UNITED STATES PATENT AND TRADEMARK OFFICE

APPLICATION NO.	FILING DATE	FIRST NAMED INVENTOR	ATTORNEY DOCKET NO.	CONFIRMATION NO.
10/656,962	09/08/2003	Ching-Fei Chen	1496-916	8819
23595	7590	07/25/2005	EXAMINER	
NIKOLAI & MERSEREAU, P.A. 900 SECOND AVENUE SOUTH SUITE 820 MINNEAPOLIS, MN 55402			HAWK, NOAH CHANDLER	
			ART UNIT	PAPER NUMBER
			3637

Office Action Summary	Application No. 10/656,962	Applicant(s) CHEN, CHING-FEI	
	Examiner Noah C. Hawk	Art Unit 3637

DETAILED ACTION

Austin, Figure 1

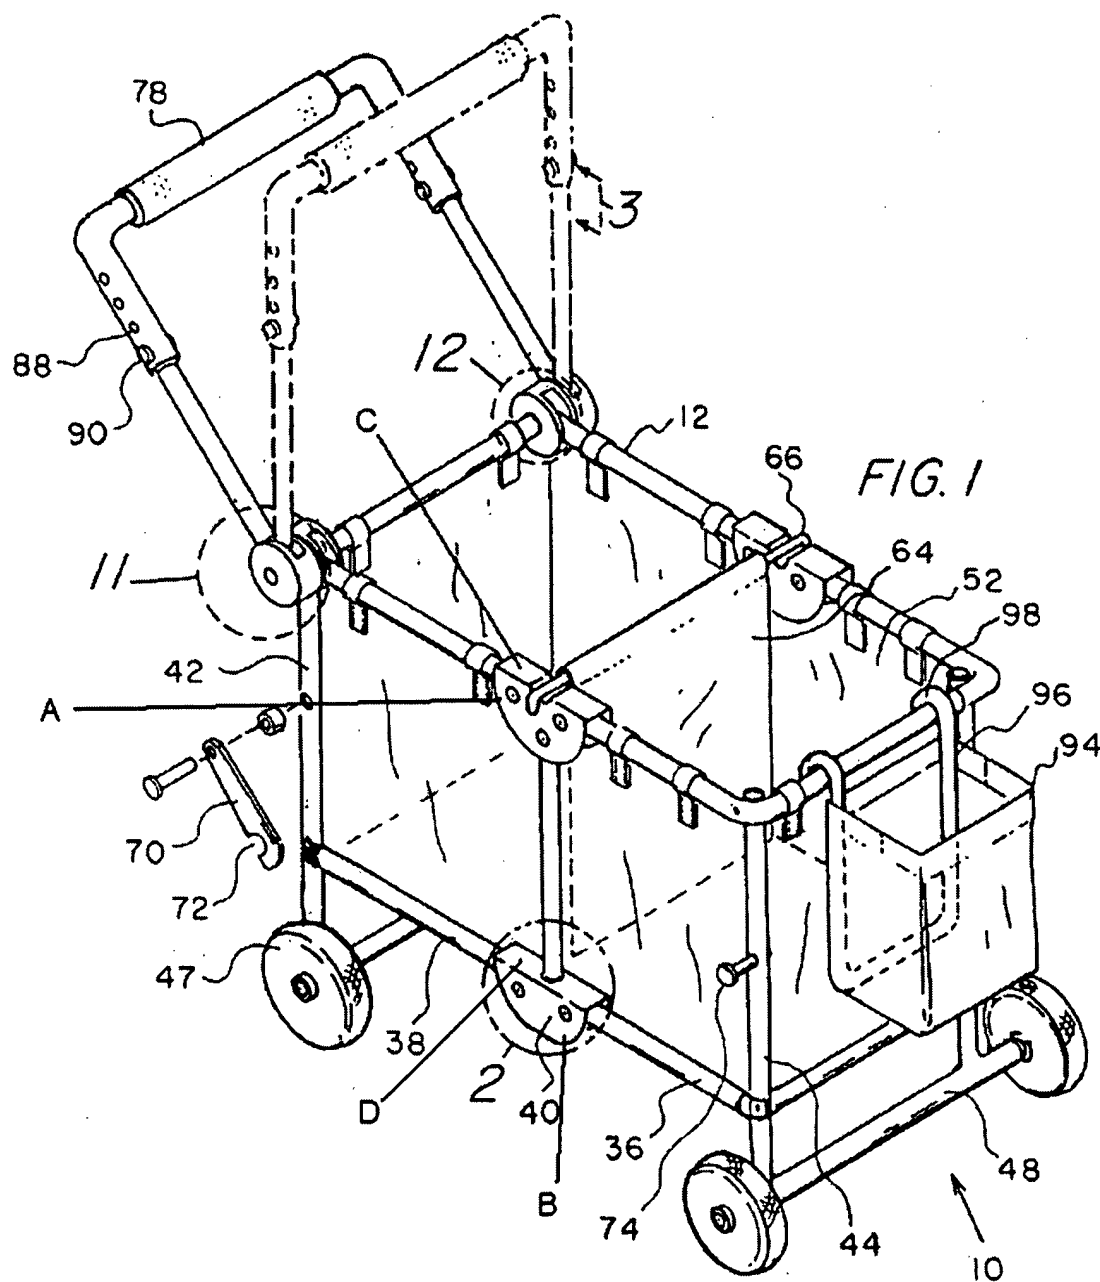
5. Claims 1-3 are rejected under 35 U.S.C. 102(b) as being clearly anticipated by Austin in US Patent 5915723. Austin discloses a foldable framework comprising four upright support rods (42, 44), two upper horizontal rods (14, best seen in Fig. 9) fastened between two of the upright rods, two lower horizontal rods (16, best seen in Fig. 9) fastened between two of the upright rods, and a folding structure at the midpoints of the upper and lower horizontal rods with an upper movable joint (24, best seen in Fig. 7) at the midpoint of the two upper horizontal rods, a lower movable joint (40) at the midpoint of the two lower horizontal rods, and a connection rod (46, best seen in Fig. 2) with a U-shaped upper end (A – the upper movable joint is significantly U-shaped, best

seen in Figure 9), a T-Shaped lower end (B – the lower movable joint projects perpendicularly outward from the lower section of the connection rod and is considered T-shaped), an upper stop portion (C), and a lower stop portion (D).
